Private Plan Change Request at 40 Mahi Road, Helensville and a Request for Further Information Pursuant to Clause 23 of the Resource Management Act 1991

Appendix A – Zoning Only Version 21/08/25 version for out of scope consideration by the Council.

Appendix B – Zoning Only Version 21/08/25 version for out of scope consideration by the Council.

Figure 5: A snip from amended precinct plan (Civix Ltd.) showing amended legend and "Potential Riparian Areas"

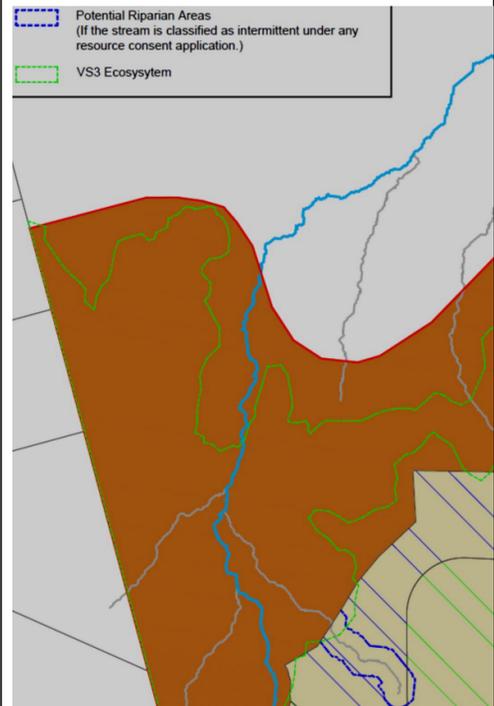
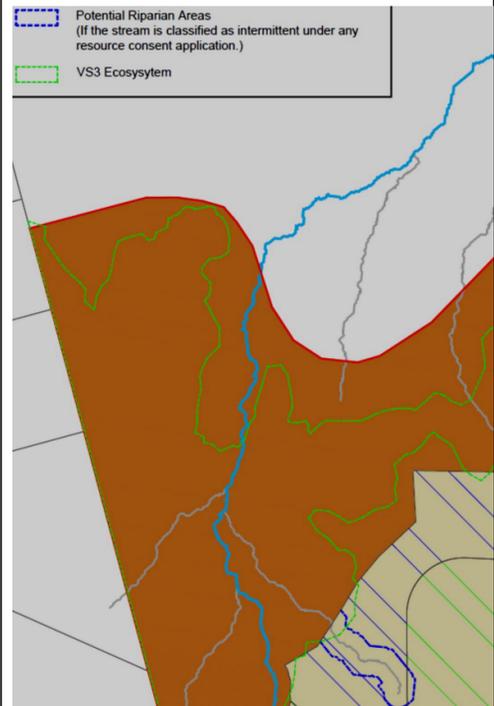
The Precinct Plan's legend has been amended to "Potential Riparian Areas (if the stream is classified as intermittent under any resource consent application)". See Figure 5 next page.

1453.9. Pukekohe East-Central: Precinct Plan 1

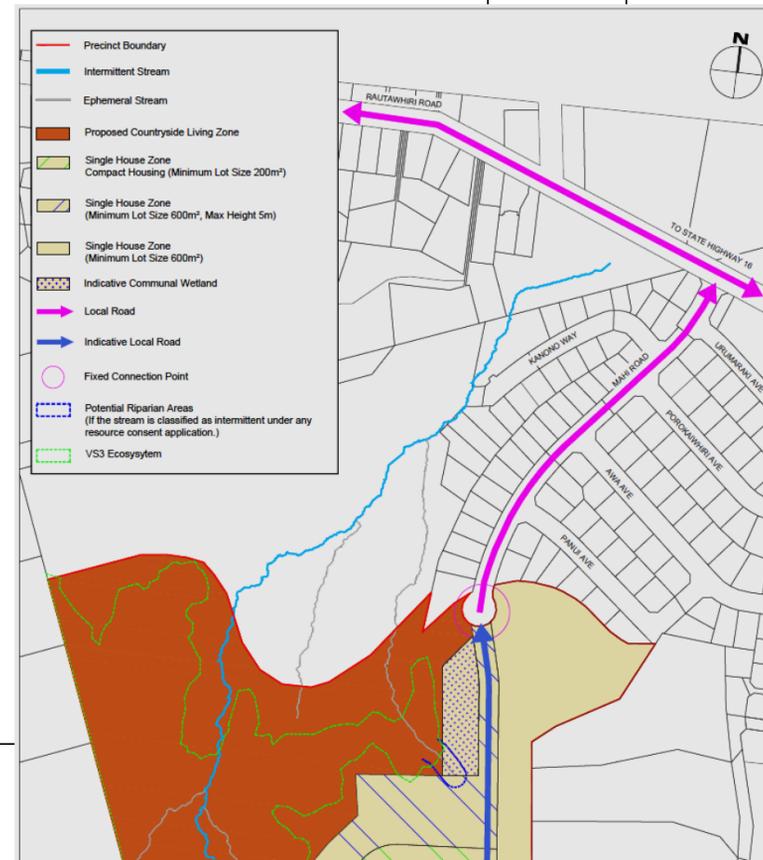
UD4	Please provide a scaled concept masterplan and precinct plan.	It is noted that the concept masterplan and the precinct plan are not to scale. A scaled map will provide a better understanding of the individual subdivision lot size and widths of proposed JOALS.	<p>Ian Munro</p> <p>I have no urban design objection to scaled plans being provided although I would reiterate that the proposal does not include a subdivision proposal and any difference of opinion on what the concept plan could have shown will not as I see it address the merits of the proposed zone or planning provisions that would apply to development. That</p>	Satisfied	Scaled precinct plan has been provided.	N/A	N/A	N/A

I have also worked on several new Precinct Plans in Auckland and am familiar with many within the AUP already – the bar-scale included in the proposed Precinct Plan was used precisely because it is the Council’s established convention. An example of a recently approved Precinct Plan is shown in the left column for the Pukekohe – East Central Precinct.

I note that the Precinct Plan has now been amended to better reflect the Council’s style guide, and this is included in the email supplying this response and also illustrated below. It is noted that the style guide enables some degree of complexity where there are different zones and overlays proposed as stated below:

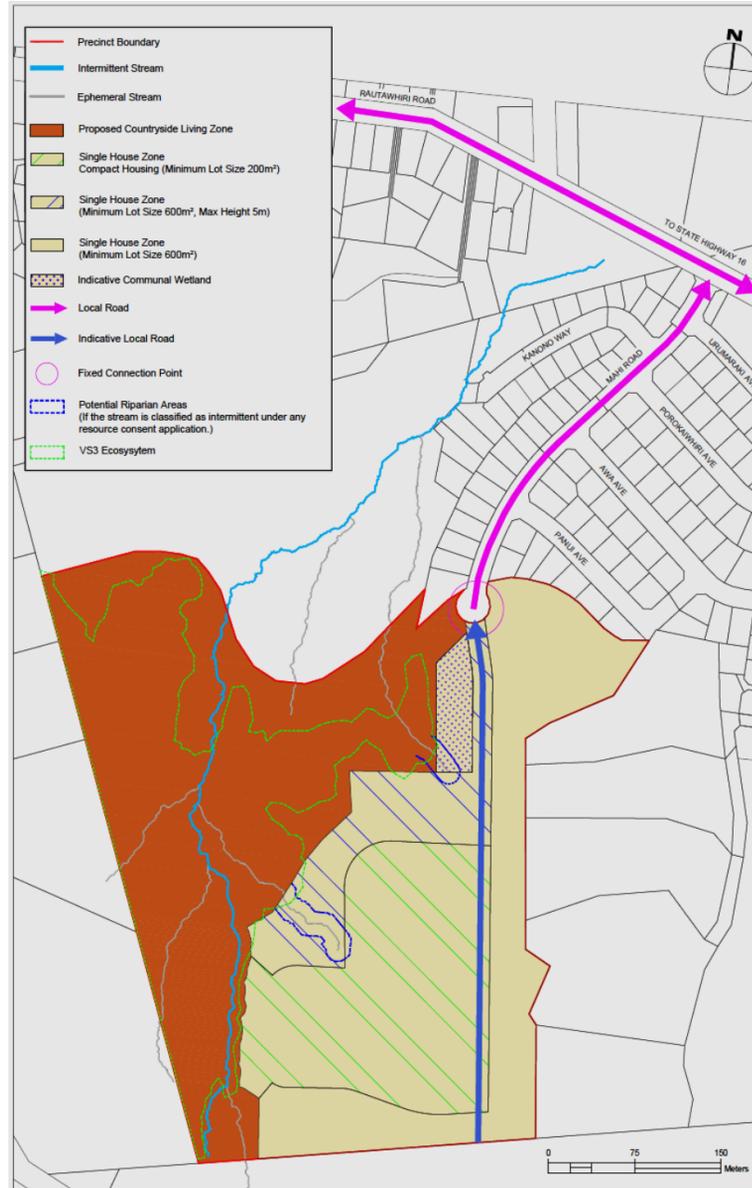
#	Provisions	Comment / recommendation	Applicant response	1st Clause 23 Request: Satisfied/ Not Satisfied	If 1st clause 23 Request Not Satisfied – outstanding information and / or Additional Clause 23(2) Request	Applicant response to items Not Satisfied
Watercare						
WCX1	I55X.1. Precinct Description	<p>The following amendments (in <u>underline</u> and striketrough) are recommended to recognise the current constraints in the public water supply network, and to acknowledge that public water supply and wastewater servicing is only intended to be provided to the SHZ.</p> <p>The 40 Mahi Road Precinct (“The Precinct”) covers approximately 17.37 hectares of land located approximately 1.40km to the south-east of the Helensville town centre. Access is via Mahi Road, a relatively new subdivision located off Rautawhiri Road. The precinct is bounded to the north by both developed and developing Residential - Single House Zoned (SHZ) land with Rural - Countryside Living Zoned (CLZ) land around all other precinct boundaries.</p> <p>The purpose of the precinct is to ensure comprehensively planned residential development occurs with an efficient yield and a range of lot sizes – recognising this is one of the few areas of suitable undeveloped residential land in a desirable elevated location outside of existing flood plains and on geotechnically stable land. A range of lot sizes <u>applicable to the SHZ</u> is reflected on the Precinct Plan as these can be readily serviced and accessed and will deliver a high level of residential amenity for future occupants. The Precinct Plan is included in Appendix 1.</p> <p>Specific precinct provisions are required to ensure quality development outcomes, and to enable flexibility in lot sizes which deviate from the standard SHZ provisions. The provisions also recognize existing ecological areas and provide suitable mitigation measures including provisions relating to riparian planting and vegetation protection. Any required stormwater drainage reserves are also identified and set out for use to accommodate future development. <u>An interim water supply solution for the SHZ has been identified due to uncertainties related to the timing of public water supply. Initial lots will be connected to rainwater re-use tanks until such time that the public water supply is available. The CLZ within the Precinct provides for self-sufficient water supply and wastewater servicing through the use of septic tanks and water tanks.</u></p> <p>The zoning of land within this precinct is the SHZ and CLZ, with provisions enabling flexibility for smaller lots in the SHZ with appropriate development standards applicable. Some areas of existing CLZ are proposed to be rezoned for SHZ purposes to more efficiently develop the land in accordance with the Concept Masterplan for the site. The provisions of the MDRS are not intended to apply.</p>	These additions are acceptable.	Not satisfied	The requested and agreed changes have not been made to the amended Precinct provisions. Please incorporate the underlined additions into the I55X.1. Precinct Description.
